Re: Reason for Request – 10600 Central Avenue SW, Albuquerque, NM 87123

Request for Minor Amendment to Site Plan - Solar Carport Installation

LUMINARIA SENIOR COMMUNITY
10600 CENTRAL AVE SE
ALBUQUERQUE, NM 87123

AM ENERGY
Luminaria Senior Community
Carport Solar PV System
10600 Central Ave SE, Albuquerque, NM 87123

SDP1.1

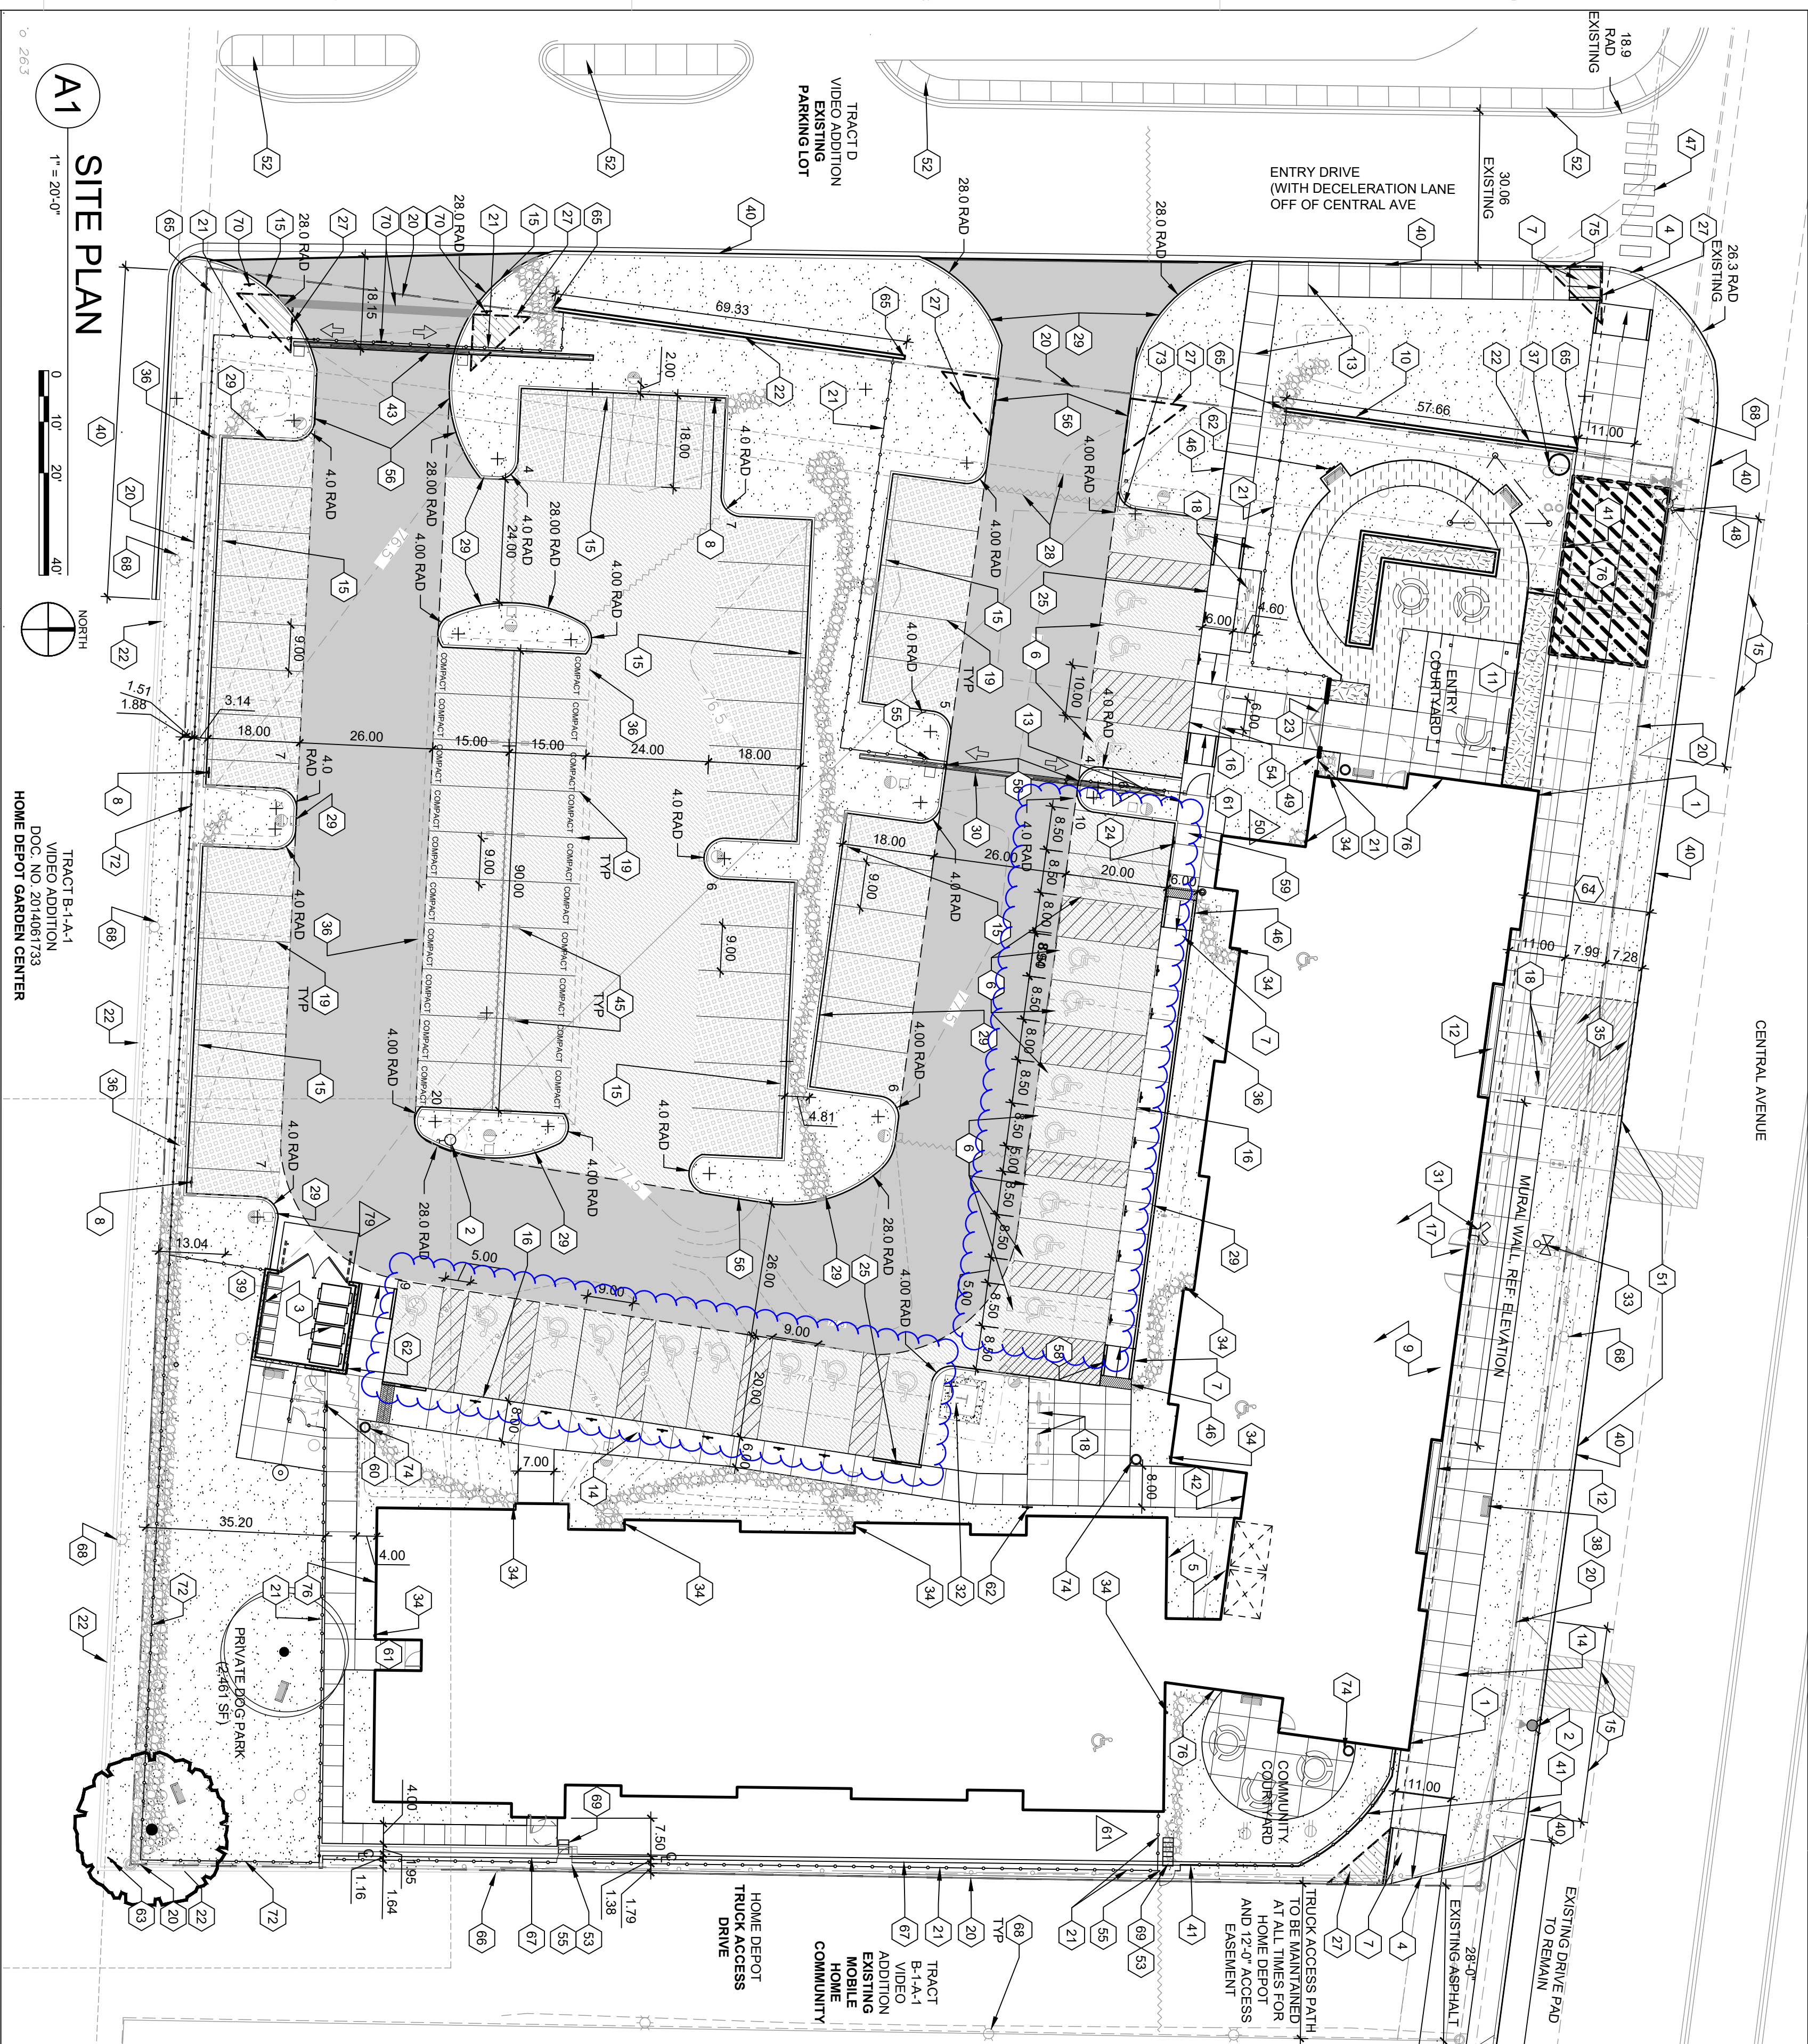
Installation of 3 carport shade structures with solar panels.

All carports are cantilever style with mono posts.

Carport 1 will be located at the North side of the parking lot over a portion (5 spaces) of the existing paved handicap parking spaces (dimensions 31'D x 84"W).

Carports 2-3 are identical will be located on the South side of the existing parking lot over (7 each) existing unpaved parking spaces (dimensions 20'D x 69"W each) and spaces will remain unpaved.

Electrical	
Site Plan, General Notes, Legend, Specifications	
DRAWN BY: JMD	PROJECT NO: 21031
CHECKED BY: JMD	DATE: 10/13/21
FLOOR SCALE: 1" = 1'	DRAWING NO: E1
	SHEET OF

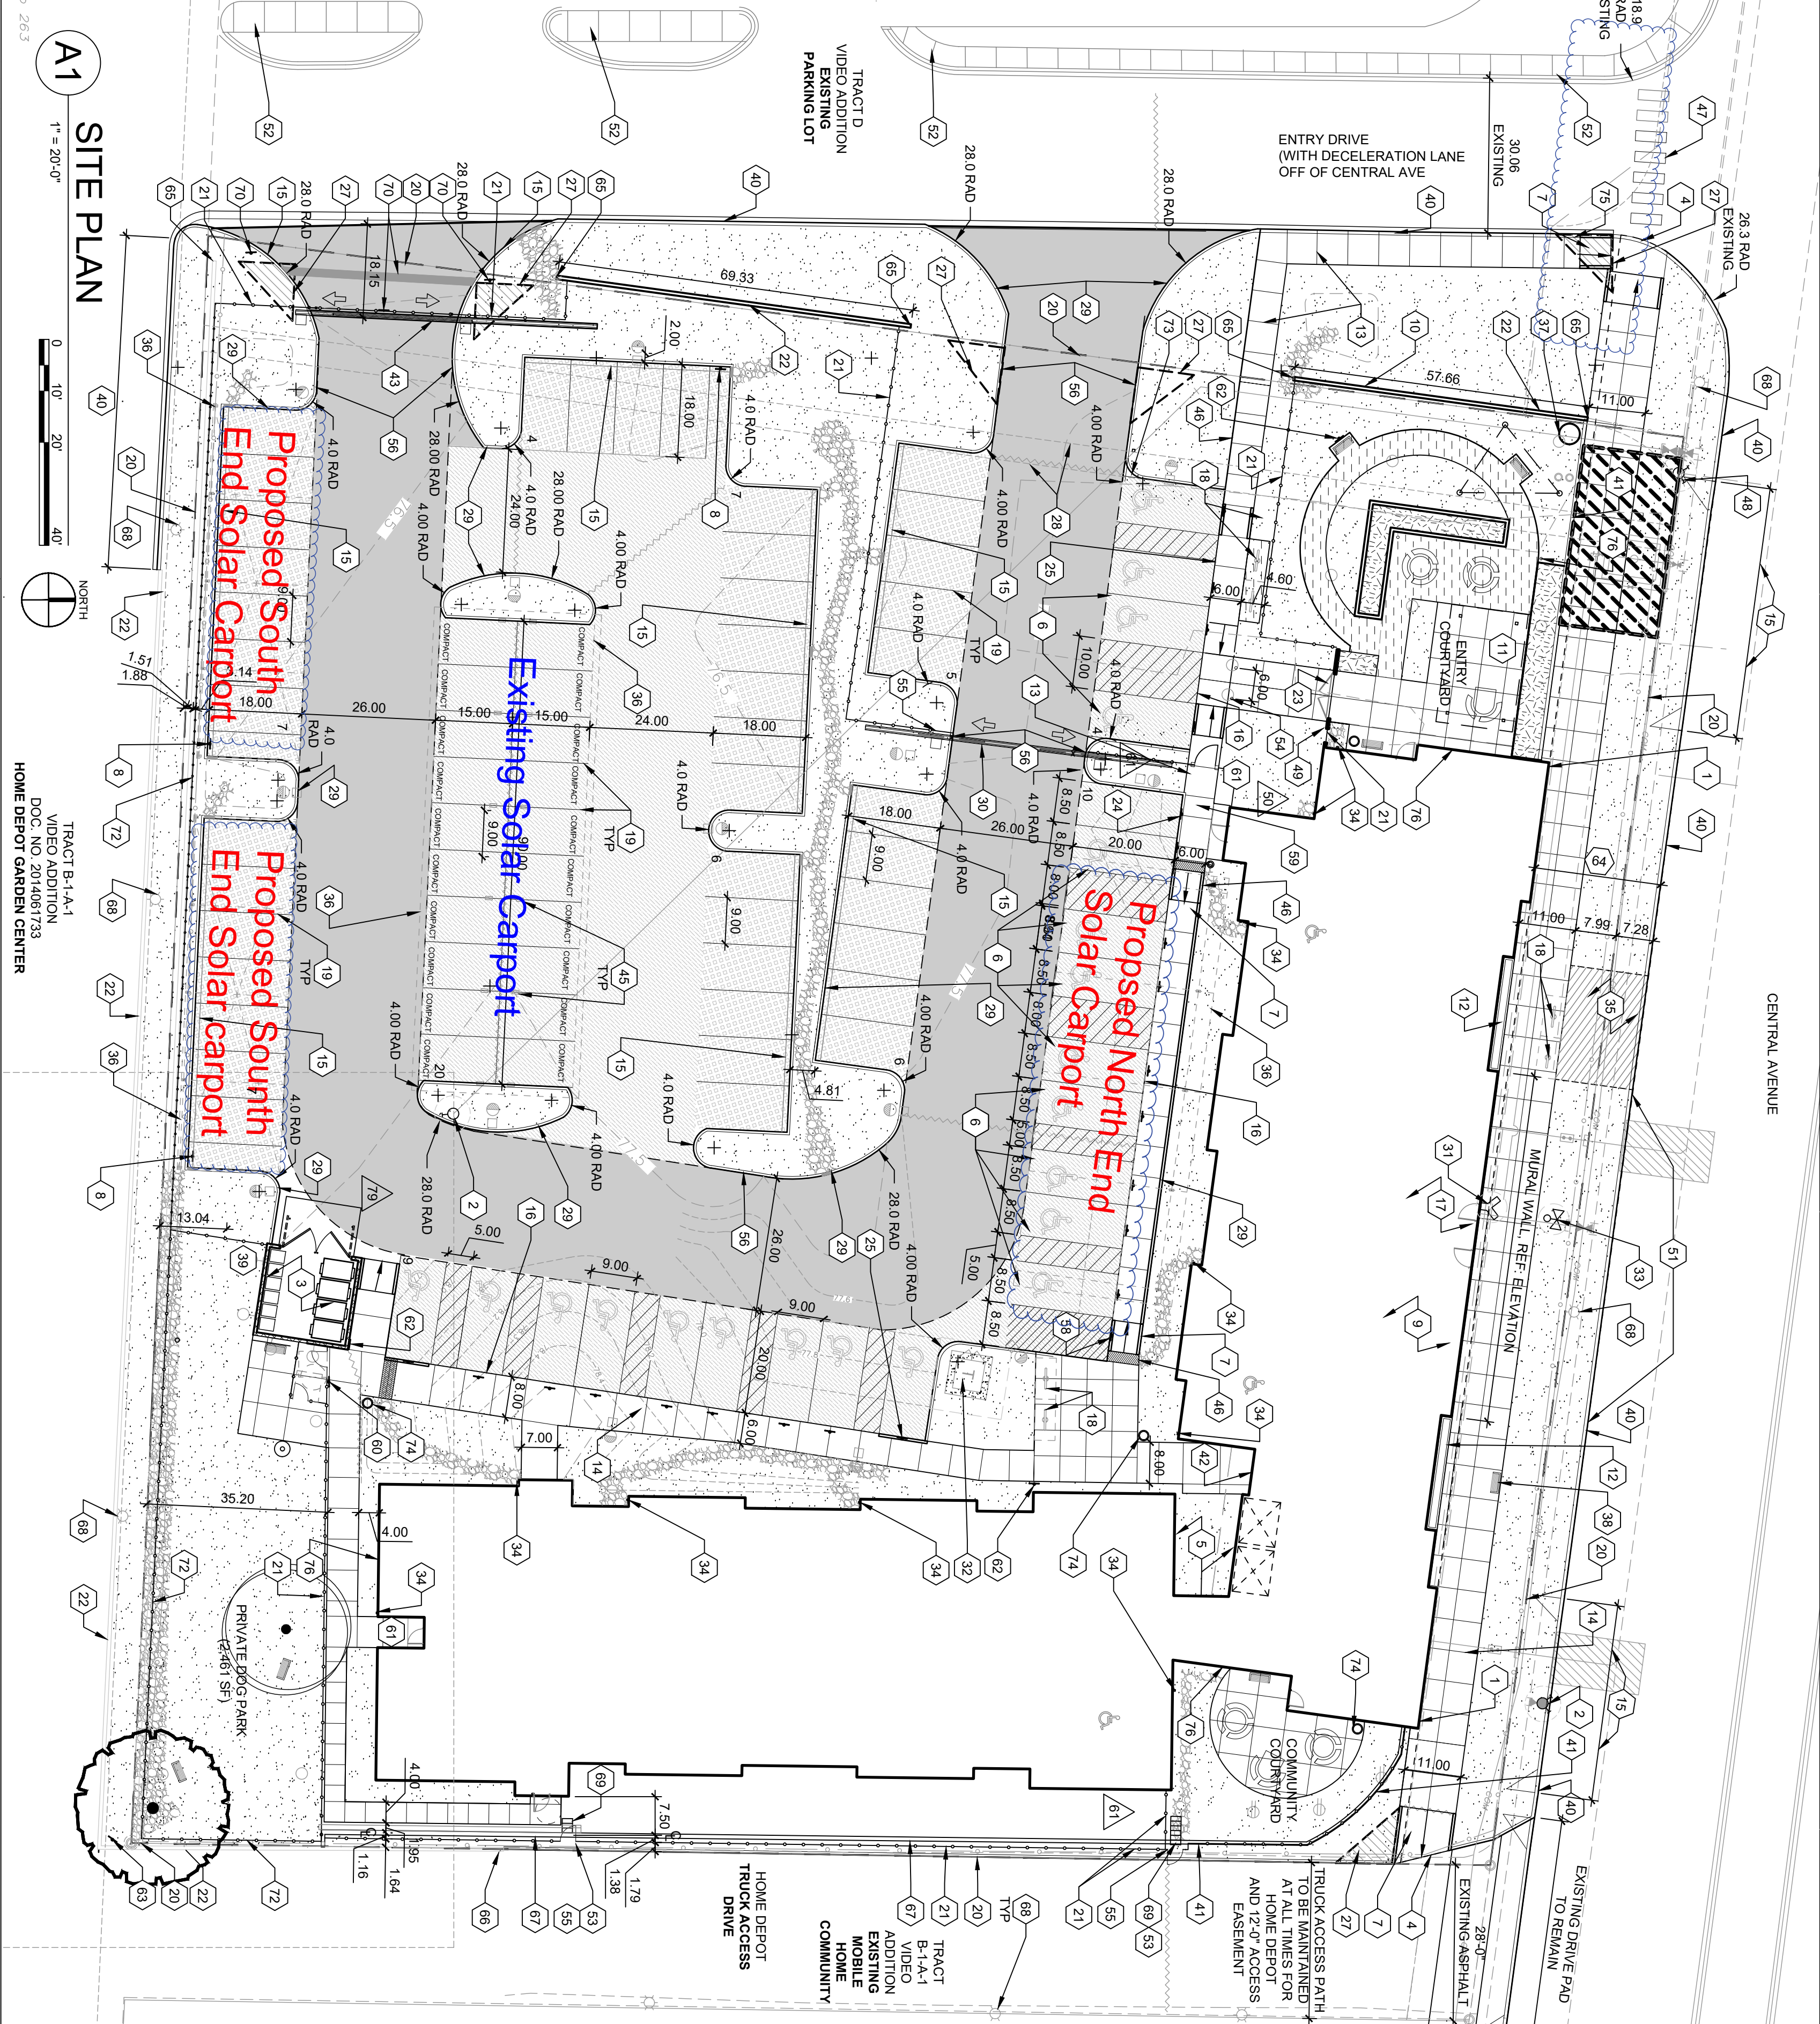
South Property line to the center of carport structure mono posts - 10'

1	Phase 2 - add array 2.1 + 2.2	JMD	12/20/22
REV NO.	REVISION DESCRIPTION	APPROVED	DATE
